Application to consolidate two parcels (P829 and P846) into one (1) lot for the construction of a 11,058 square foot medical office building.

PRELIMINARY PLAN NO. 120230010

> Revised RE: Preliminary Plan No. 120230010 Hillcrest Property

Figure 5 – Interim Hillcrest Avenue Cross Section

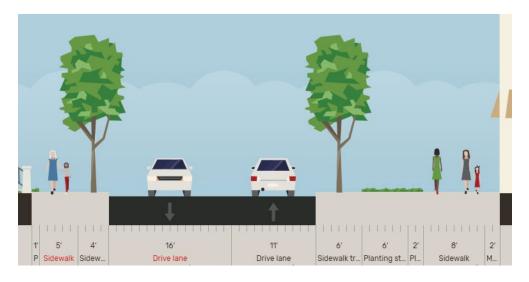
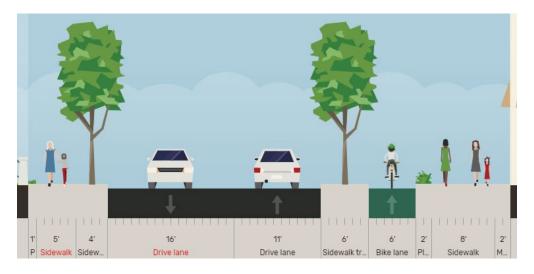
- 1. Hillcrest Avenue is classified as Town Center Street. Per the Master Plan of Highways and Transitways the minimum required right-of-way (ROW) is 70-foot. We recommend the applicant dedicate to conform to the master plan.
- 2. MCDOT's November 29, 2022 letter stated the following:

We <u>do not agree</u> with the Applicant's proposed roadway cross section for Hillcrest Road frontage as shown in the plan. The certified preliminary plan shall reflect the following proposed interim frontage improvements from edge of property line to the relocated edge of curb:

• 2-foot minimum maintenance buffer

- 8-foot sidewalk
- 8- foot Grass Strip which would be converted to an ultimate cross section in future which would include 2-foot pedestrian/bike buffer with a 6-foot bike lane
- 6-foot tree panel buffer

The applicant has since changed the cross section along their street frontage. Per the cross section shown on the preliminary plan sheet #2 of 5 that is uploaded to eplans on March 3, 2023, the applicant is providing the cross section listed above. MCDOT continues to agree with this cross section.

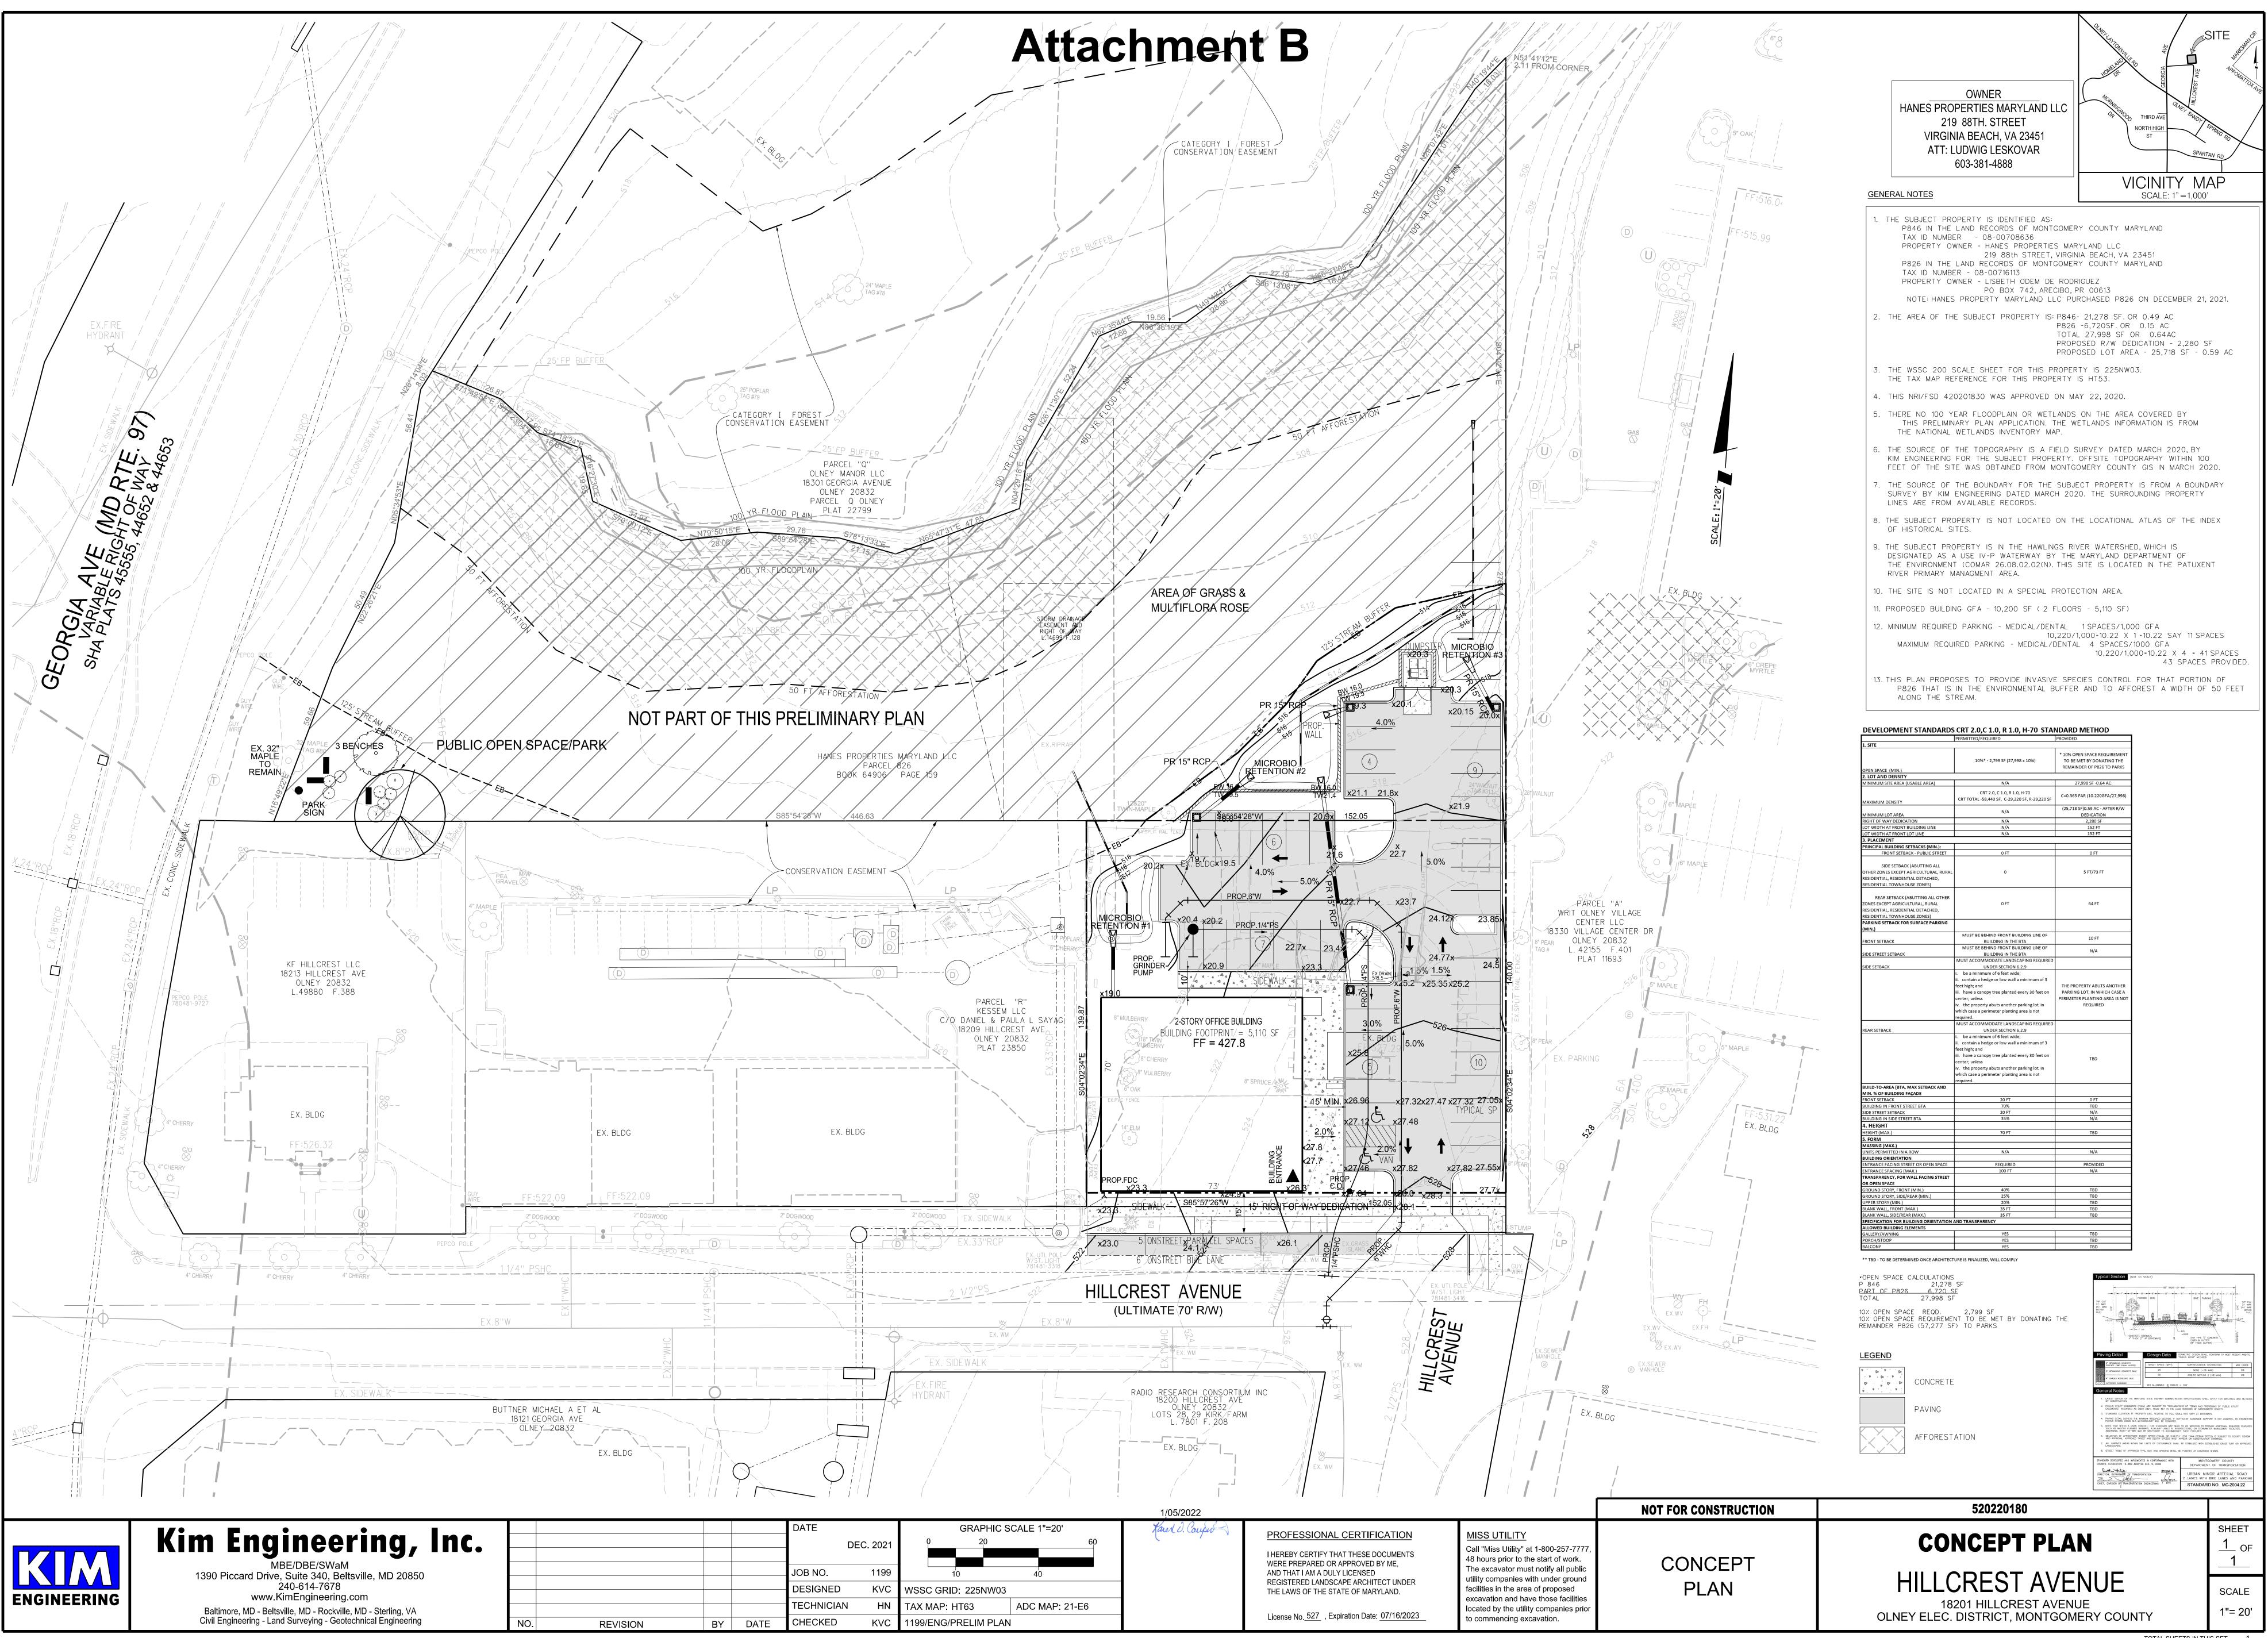
<u>Sight Distance:</u> The sight distance does not meet the minimum 200-feet required. We <u>do not</u> <u>approve</u> the sight distance since the sight distance is obstructed by proposed street parking. We do not agree with the street parking as proposed. Prior to the Certified Preliminary Plan, the sight distance at the driveway shall be revised to meet the minimum requirements based on the interim roadway cross section as per the above comment.

The applicant has revised the cross section to pull the curb out in the preliminary plan sheet 2 of 5 that was uploaded to eplans on March 2, 2023. This new location of the curb allows for the applicant to meet sight distance. Therefore, MCDOT approves the sight distance with this preliminary plan. The form is enclosed with this letter.
